27/6/2023

Representation for Hobart Draft Local Provisions Schedule – Flood Prone Area Hazard Overlay in respect of [REDACTED] Sandy Bay

Photo of the stormwater drain and that it is lower than the remainder of my property

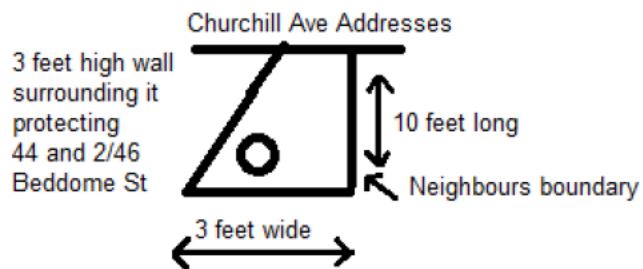
The stormwater drain is located at the bottom edge of my property boundary and is located down a 3 feet shaft which surrounds it.

3 feet high wall all around there is no way water will reach above this in an event.

3ft tall between stormwater lid
and top of wall

Slope downward
